115 Frognal Ref: 2017/2917/P

Amendments to planning permission 2016/5380/P to allow the creation of a basement, alterations to fenestration, installation of air-con units on roof of garage

Extract from the noise assessment report showing the monitoring location (F) and assumed AC location

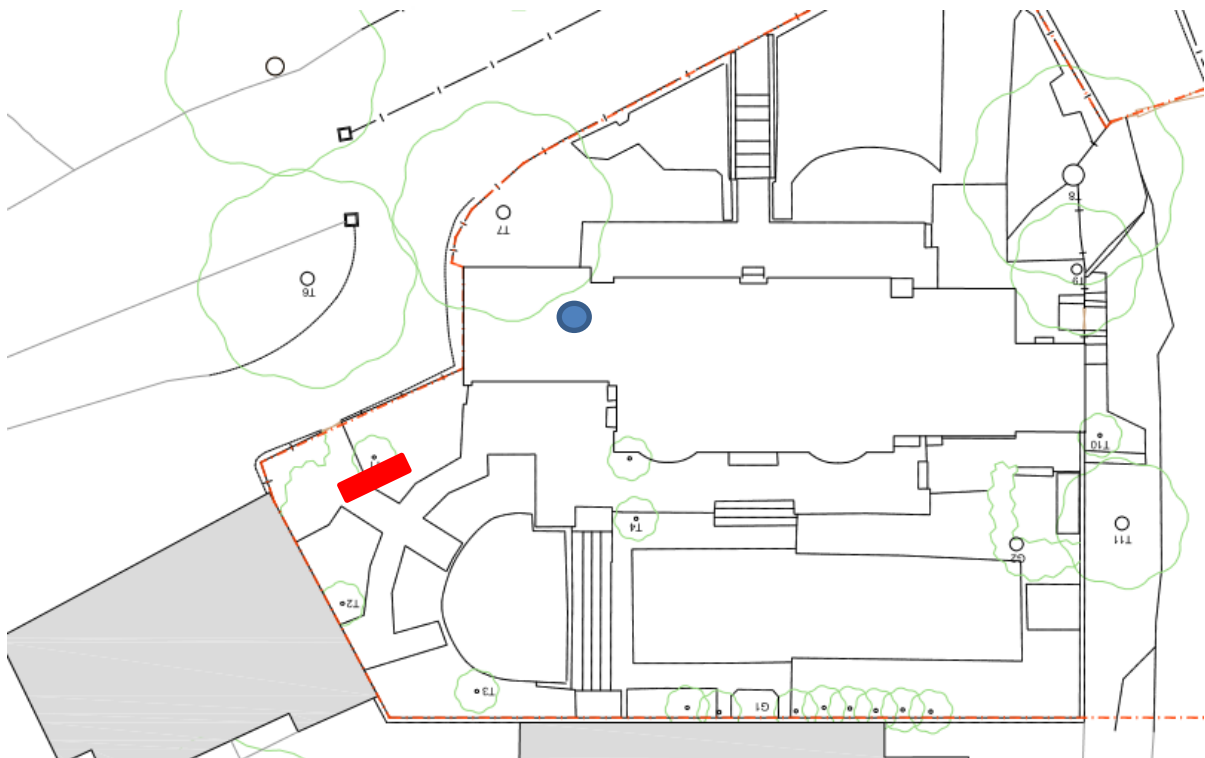
We do not agree that the location used to record the background noise is directly comparable.

It is estimated that the monitoring location shown in the noise report is at its closest approximately 8.5 metres from the actual location where the AC units are proposed and approximately 12 metres from the furthest proposed unit.

The location where noise readings were taken is closer to the main road and Oak Hill Way than would the units be situated when installed.

In addition to this, the position where the units are proposed to be located is set back from the road and screened by 115 Froggnal and the neighbouring garage block such that background noise levels in this location would be less and so not comparable to the measured location even leaving aside the above concerns.

It is our experience that where similar monitoring is undertaken elsewhere, a pole would be erected in the correct location to allow monitoring equipment to gain a fair reflection of the background levels in exactly the correct position.

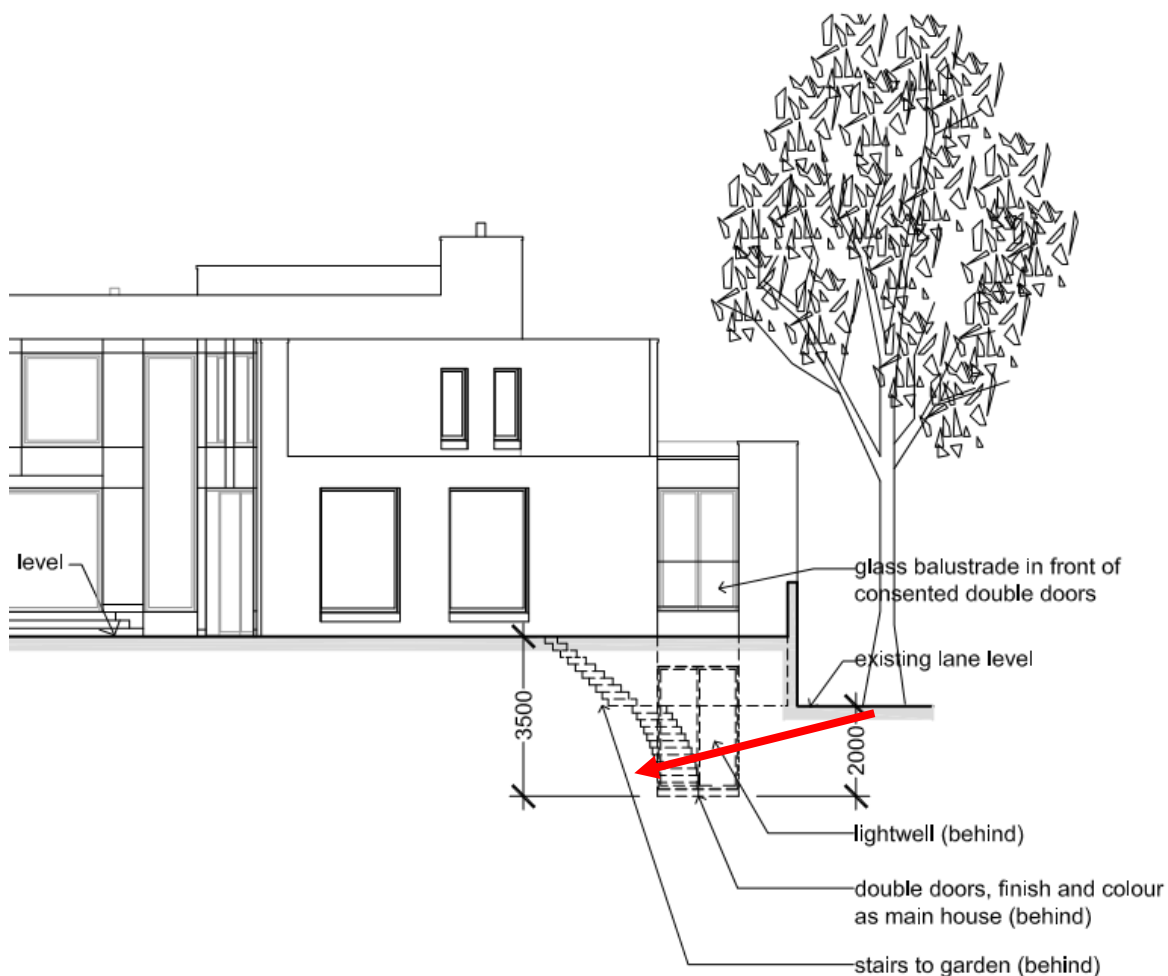
However, as demonstrated below by the applicants elevation drawing the tree stands well below the existing ground level of the house. It is not clear that the roots from the tree don't spread significantly under the garden wall and so could be damaged by the major basement construction works.

It is submitted that the tree officer should satisfy himself in this regard with an investigatory trench being opened up (through careful hand digging) adjacent to the wall.
